## Firmware 2.06.3 bug list:

## List of bugs/improvement requests

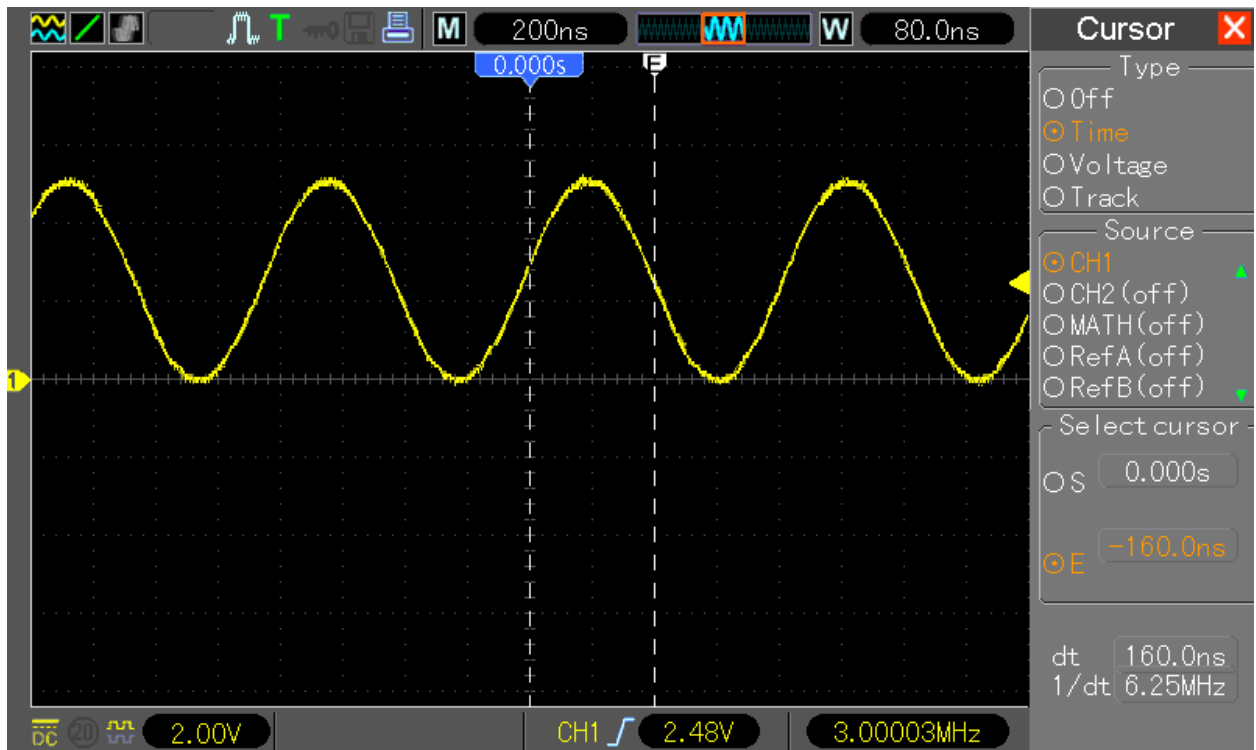
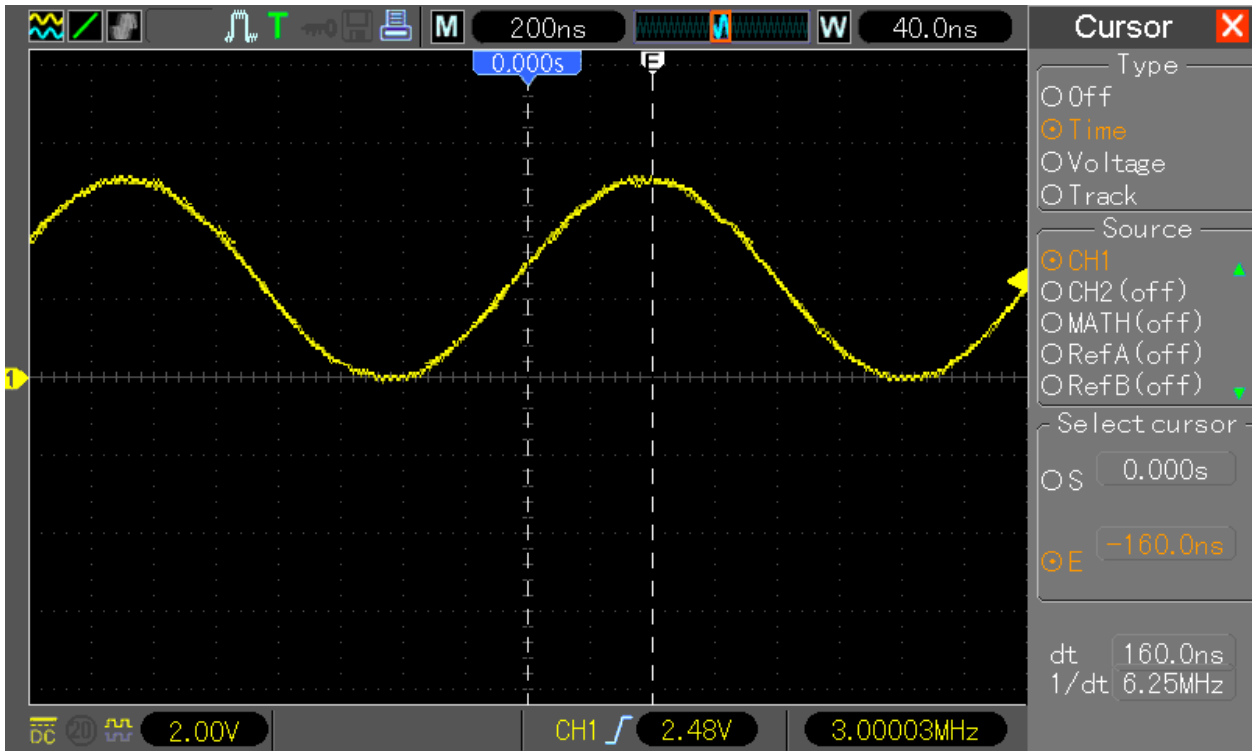
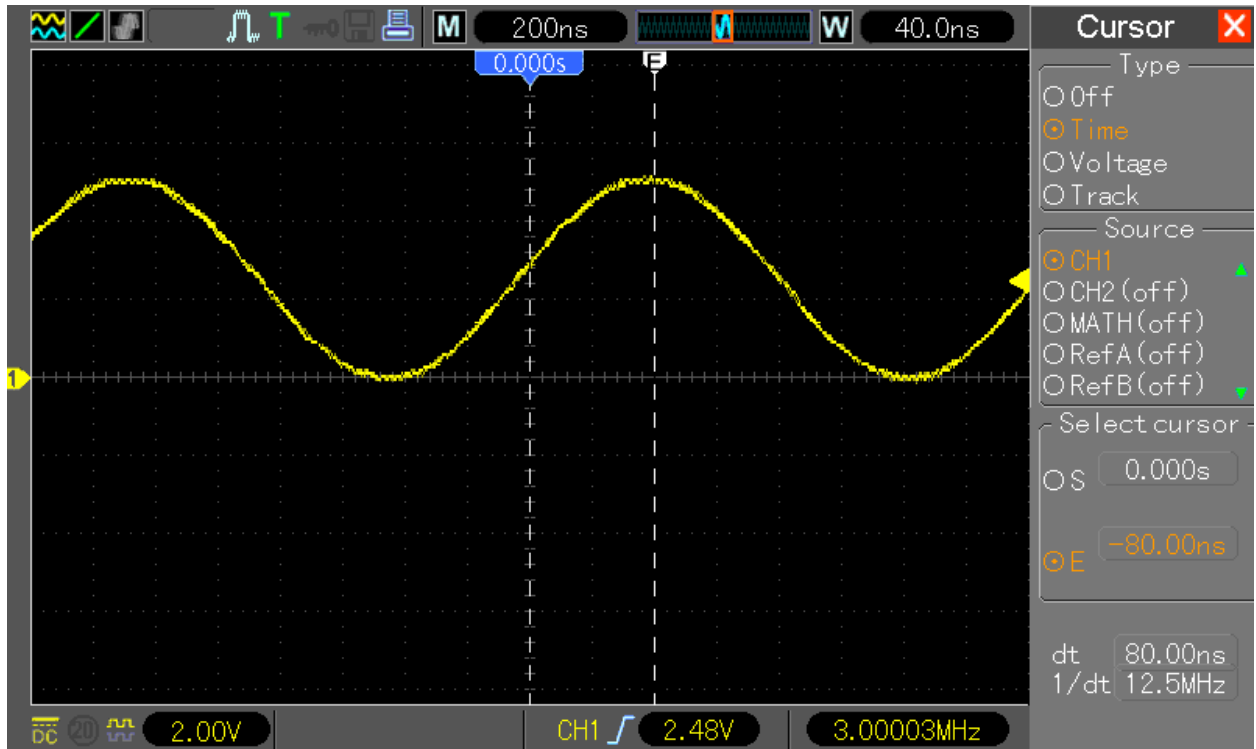
31. In RUN and STOP mode, while changing Timebase the Time Cursor values S and E not refreshing automatically. Any changes to Menu (hide/show with F0), other Knobs (like V0) position or any Buttons (e.g. push Measure button and again Cursor button) is refreshing the S and E values in Menu.

Here example, TB set to 80ns/DIV, cursor S to 0.0ns and E to -160ns:

Then TB changed to 40ns/DIV, but displayed value for E still -160ns:

Now disabling Menu with F0:

and enabling Menu again with F0. The E cursor value is now having proper value (-80ns):

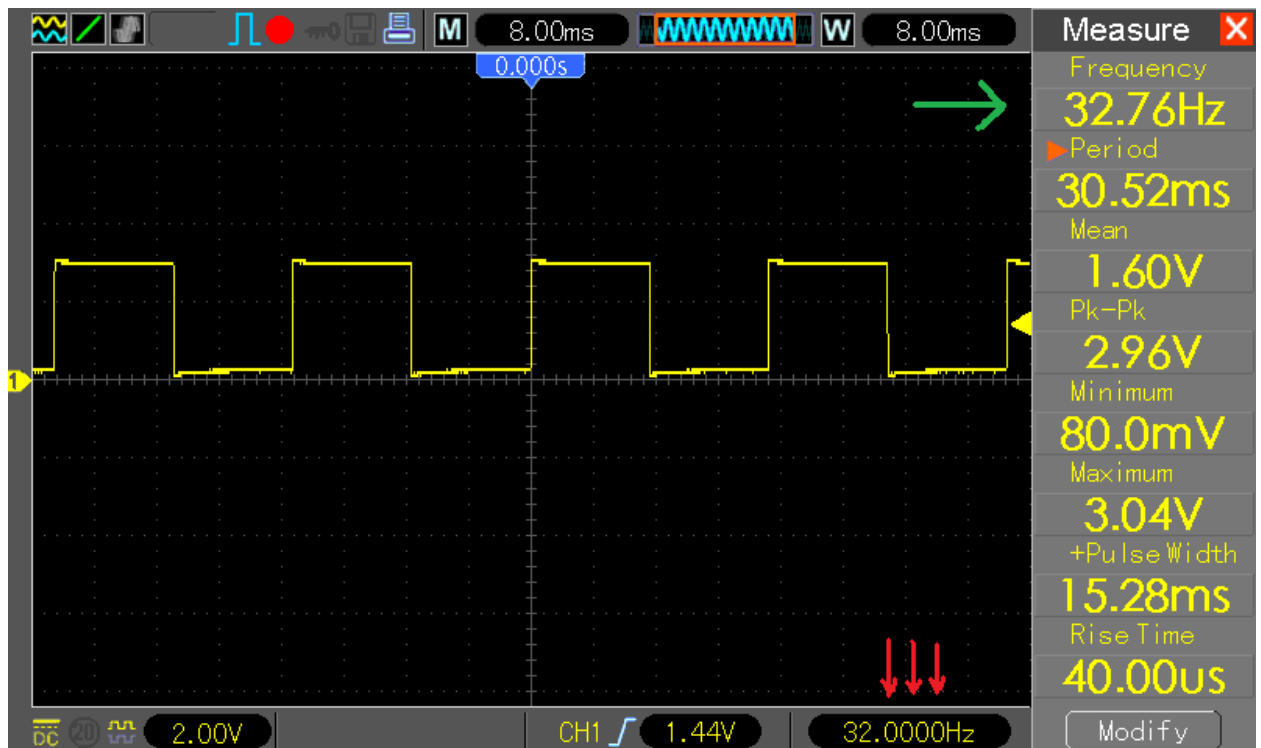
34. CSV Exported data, if MTB from 40s/DIV to 4ms/DIV the amount of samples is wrong as well the displayed MTB value seems to be wrong. Example :
  - 4k depth, 4ms/DIV -> CSV shows #timebase= -294967296(ps) and not 400000000(ps)

**The number -294967296 is nothing else than buffer overflow by 3999999999, -589934592 buffer overflow by 7999999999, etc.**

A quick check of “SaveWaveDataToCSVFile” shows the problem source ->

**sprintf “#timebase=%d(ns)\r\n,”** is using %d but I think %lld was supposed to be there to allow maximum of 40s/DIV to be saved in pico seconds. The “RecallCSVDataToDispBuf” need of course to be changed as well to allow read-back of the CSV data longer than 2000000000 ps.

32. Nothing to say here.
33. Nothing to say here.
34. We could patch it with Hex Editor from %d to %lld to allow CSV export, but import need to be changed in source code (to work properly), so I would say “let’s wait for official fix”.

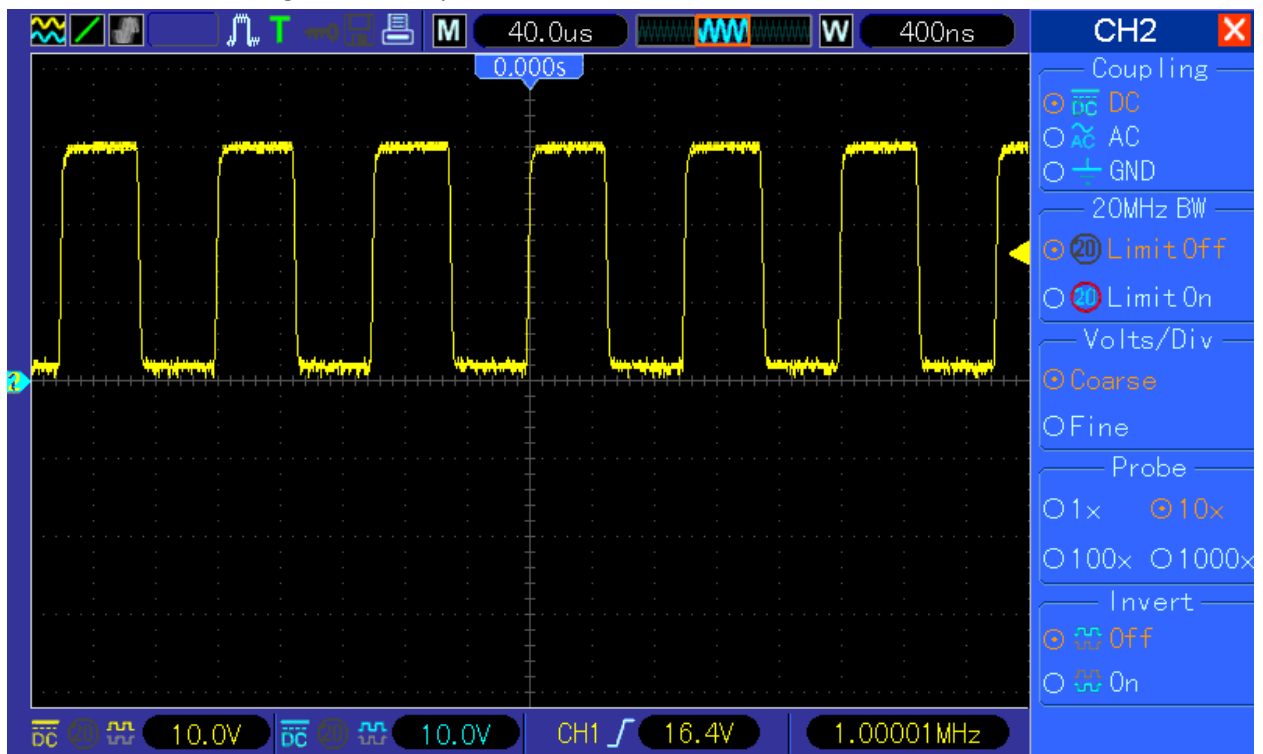
36. If possible change the Frequency Counter to display in mHz resolution when counter value between 1Hz and 99.999kHz (99999Hz). If not possible change displayed value to cut (trailing) zeros, when there is no mHz no need to see zeros instead (e.g 10Hz should be shows as 10Hz and not 10.0000Hz). This might be sometimes very confusing for the user, imagine e.g. frequency of 32.768Hz – the counter will show 32.000Hz (and Wave measure 32.76Hz).

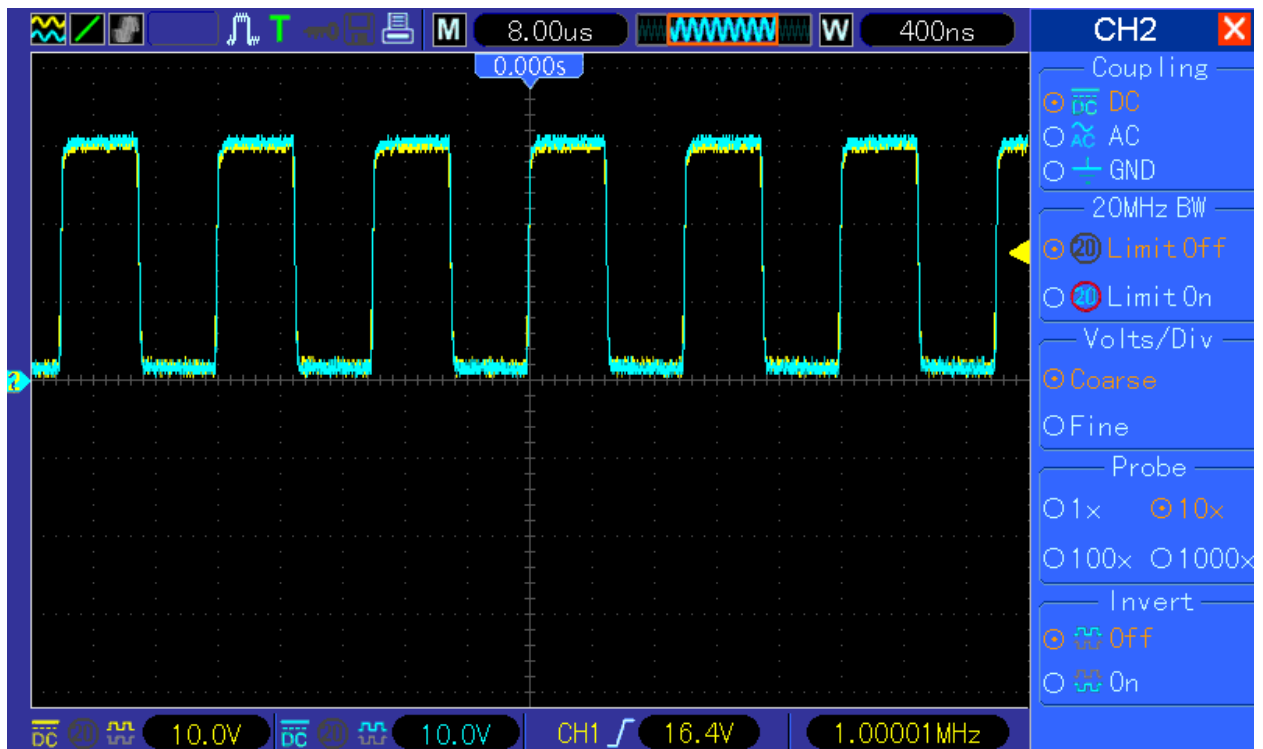
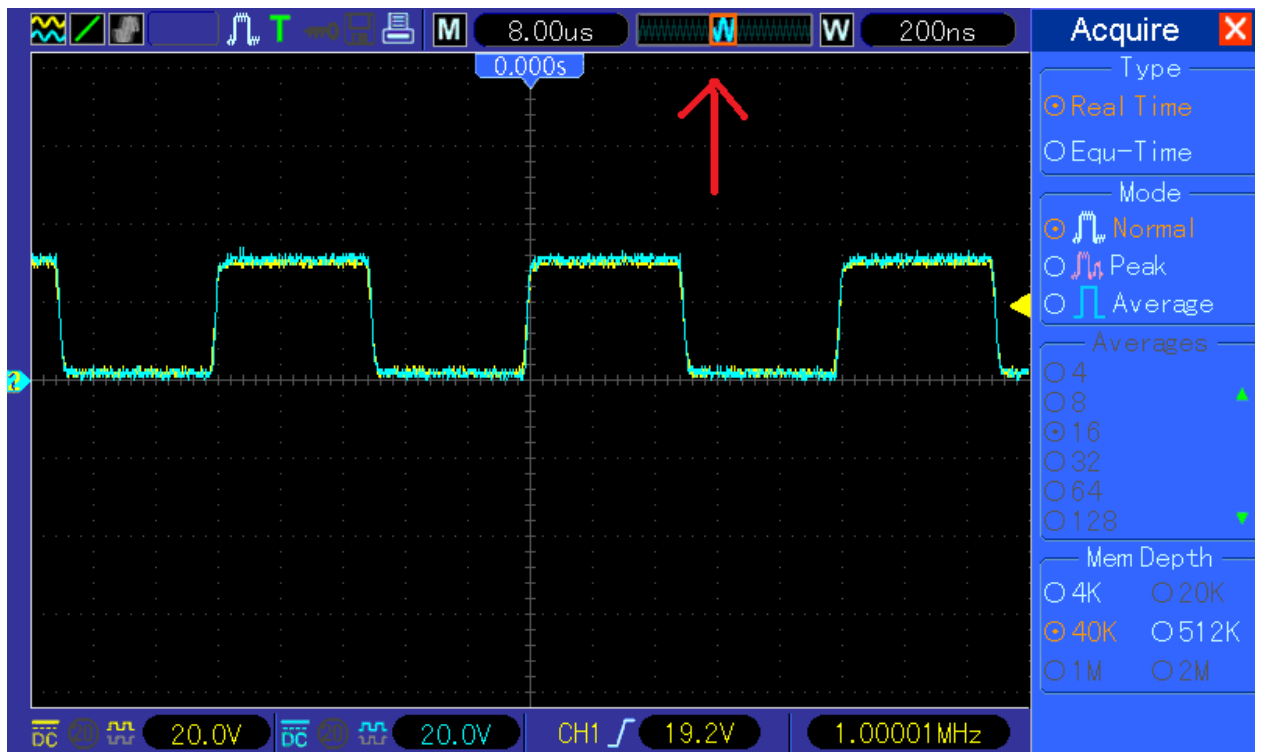
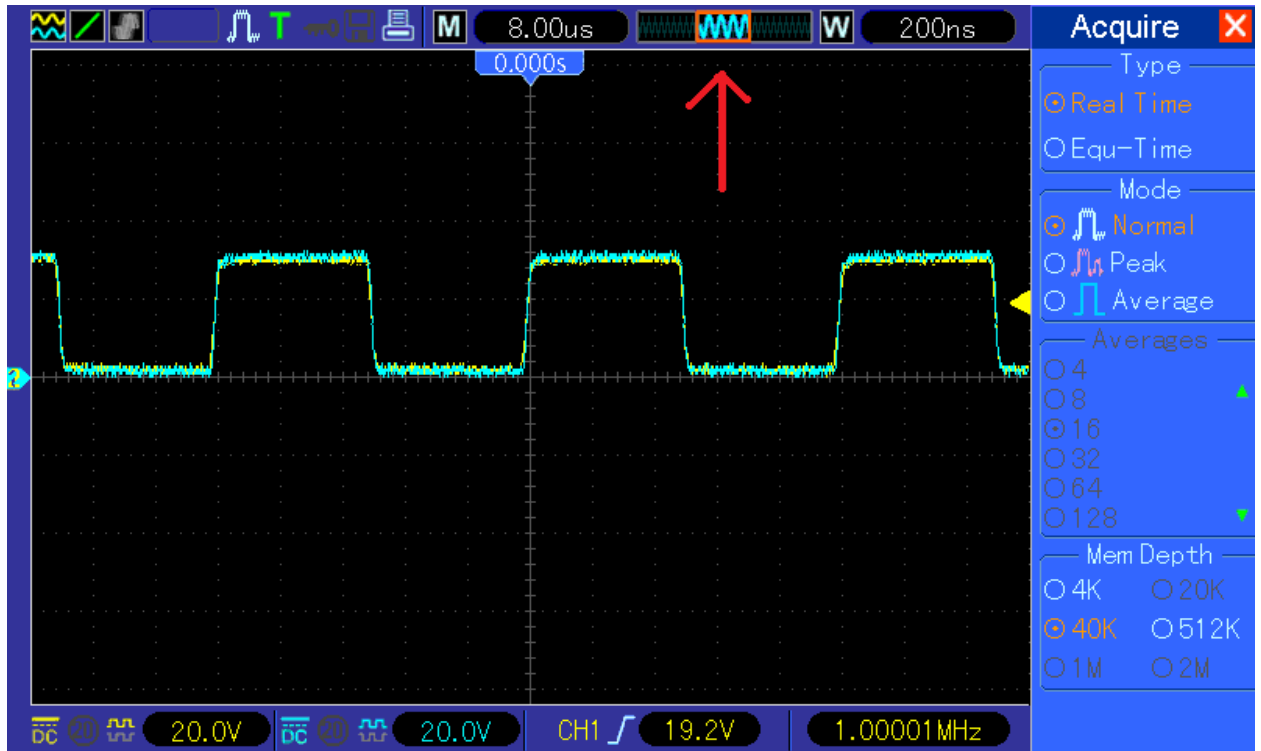
37. With Long Memory enabled (40k, 512k, 1M, 2M?) when the WTB is 400ns/DIV (and lower, up to 2ns/DIV) when enabling second channel the indicator in status line will be already displayed but the waveform is missing. Additionally the CH2 LED is off :

But after changing Timebase (or wave position) one position forth and back the second channel waveform will get displayed and LED gets on :

36. Not a bug, but who need to see trailing zeros?
37. Turn Timebase knob one position forth and back.
38. This is funny bug, isn't?
39. Turn Timebase knob one position forth and back, in most cases the Sampling Rate within FFT will be then updated to proper value.
40. ~~Ensure that no more than 10 file on the Flash Drive.~~

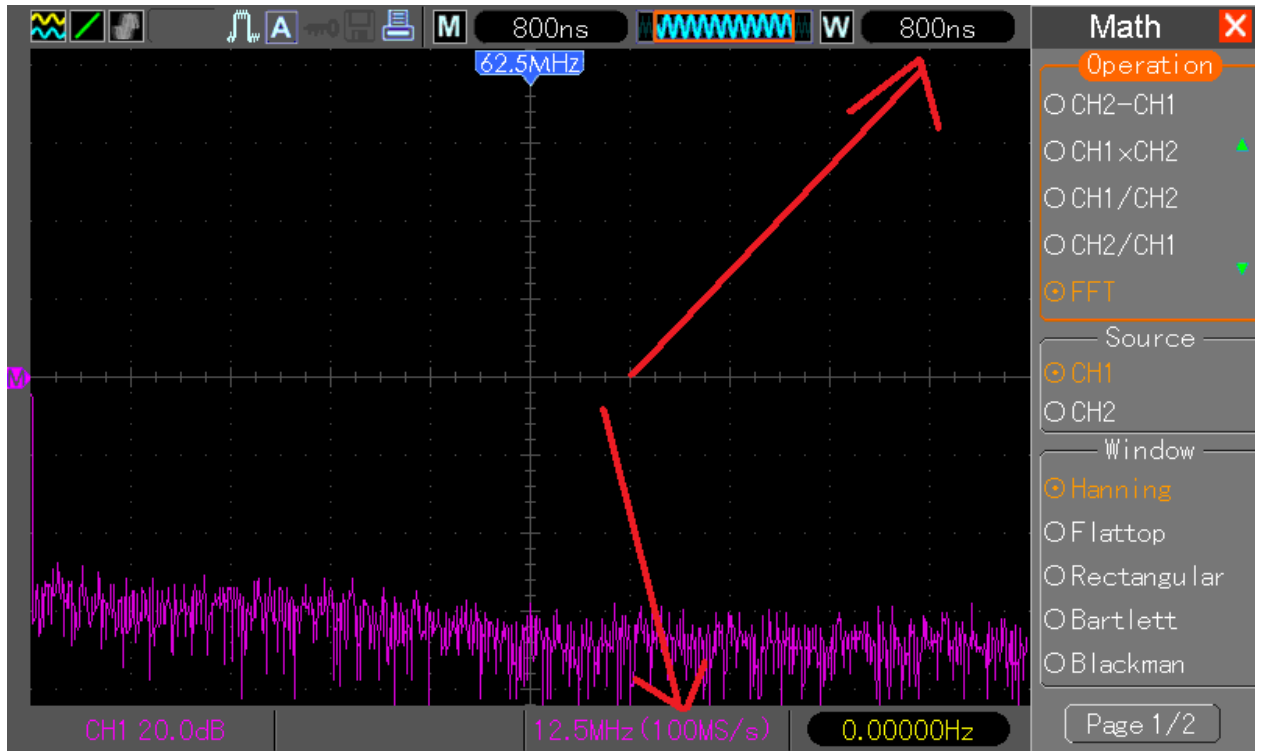
38. MTB Area indicator is blinking! Select 40k depth (or 512k), enable both channels set WTB to 400ns/DIV or 200ns/DIV and watch the area blinking :
